Tax ID # 05-451965
ON-SITE SEWAGE DISPOSAL SYSTEM
HOWARD COUNTY HEALTH DEPARTMENT
BUREAU OF ENVIRONMENTAL HEALTH

SUBDIVISION: The Warfields II LOT NUMBER: 27

ADDRESS: 14855 Michele Drive PROPERTY OWNER: NVR Inc.

HOUSE LOCATION DRAWING

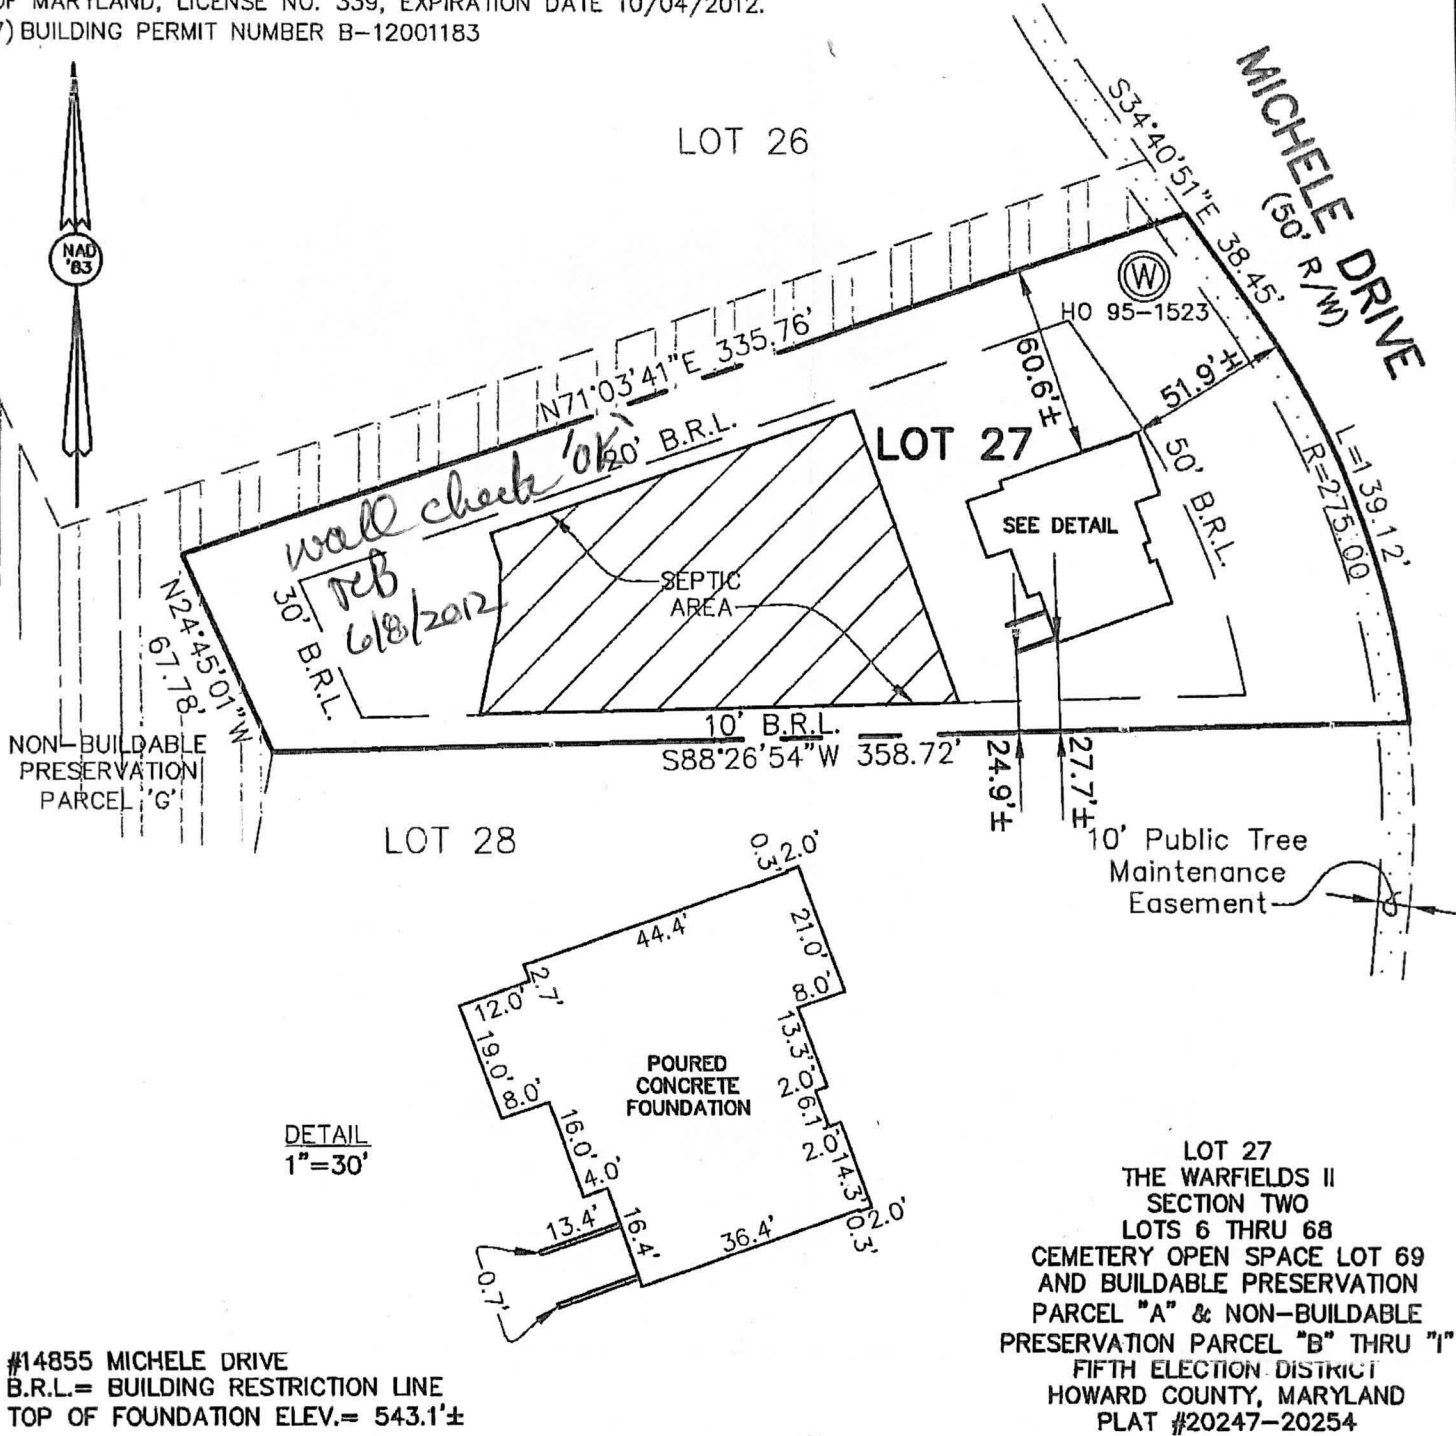
6/29/2012 Install three 41' trenches on contour as high as possible in the northern part of the easement. Install the tank near where shown on the B.P. plan. (BB)

7/10/2012 Layout redone. (KW)

7/12/2012 System finished. O.K. to backfill. (BB)
